APPLICATION NO.	FILING DATE	FIRST NAMED INVENTOR	ATTORNEY DOCKET NO.	CONFIRMATION NO.
10/661,324	09/12/2003	Bodo Ehlers	FHN-106-B	9310
7590 09/08/2005 Christopher A. Mitchell Suite 624 3001 West Big Beaver Road Troy, MI 48084-3107			EXAMINER GOLUB, MARCIA A	
			ART UNIT 2828	PAPER NUMBER

Office Action Summary	Application No. 10/661,324	Applicant(s) EHLERS ET AL.	
	Examiner Marcia A. Golub	Art Unit 2828

DETAILED ACTION

FIG. 10A

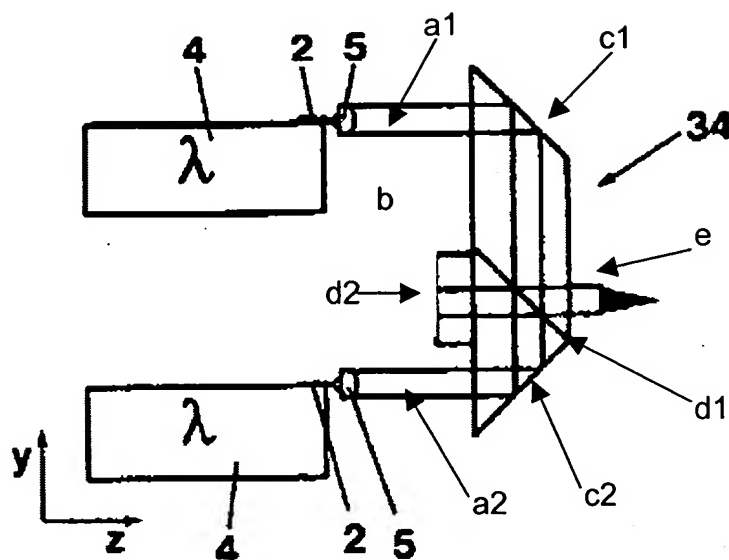
Regarding **claims 1-18** Fig 10A of Du discloses “An apparatus for shaping part of the collective output beam of a plurality of semiconductor lasers comprising individual bars of semiconductor lasers [2] stacked one on top of the other to form an array, the plurality of semiconductor lasers being arranged to define a plurality of light-emitting areas [a1, a2] and a plurality of non-light- emitting areas [b], and the array having dimensions in X, Y and Z axes, wherein the Y axis defines a fast axis, the X axis defines a slow axis, and the Z axis defines an axis of propagation for the output beam, the apparatus comprising:

a first reflective member [c] comprising at least a first reflective element [c1] positioned a fixed distance from each bar in the array, the at least first reflective element adapted to deflect a first portion [a1] of the output beam from each bar in the array in a first direction [-y direction] oriented at a first angle [0 degrees] in the slow axis direction and at a second angle [90 degrees] in the fast axis direction,

at least a second reflective member [d] comprising at least a first reflective element [d1] positioned a fixed distance from each bar in the array, the at least first reflective element of the second reflective member adapted to deflect the first portion of the output beam from each bar from the first direction [-y direction] to a second direction [z direction] oriented in the Z axis direction;

and whereby the first portion [e] of the output beams of each bar in the array are oriented approximately parallel to the un-deflected remainder [a1] of the output beams

wherein: the first reflective member [c] further comprises a second reflective element [c2] positioned a fixed distance from each bar in the array, the second reflective element adapted to deflect a second portion [a2] of the output beam from each bar in a third direction [y direction] oriented at a third angle in the slow axis [0 degrees] direction and at a fourth angle [90 degrees] in the fast axis direction;

the at least second reflective member [d] comprising a second reflective element [d2] positioned a fixed distance from each bar in the array, the at least second reflective element [d2] of the second reflective member [d] adapted to deflect the second portion [a2] of the output beam of each bar from the third direction [y direction] to a fourth direction [z direction] in the Z axis direction;

and whereby the first portion and second portion [e] of the output beams of each bar in the array are oriented approximately parallel to the un-deflected remainder [a1,a2] of the output beams of each bar, and the non-light-emitting areas are substantially eliminated from the output beams [two light beams are combined into one light beam];

wherein the third direction [y direction] is approximately opposite the first direction [-y direction], the first and third angles are approximately the same [0 degrees], the second and fourth angles are approximately the same [90 degrees], and the second and fourth directions are approximately the same [z direction];

further comprising at least one optical member [5] adapted to balance the optical path length of the un-deflected remainder [a1, a2] of the output beam of at least one of the bars in the array, the at least one optical member being disposed at a fixed position in the axis of propagation of the un-deflected remainder of the output beam;

wherein the total height of the first and second reflective members corresponds to the pitch of the semiconductor lasers in the array [reflective members c and d encompass all the light produced by laser bars 2];

wherein the output beams [a1, a2] of each bar in the array are propagated in a direction substantially perpendicular to a plane defined by the X and Y axes." [output beams are propagating in the z direction, which is perpendicular to the xy-plane]
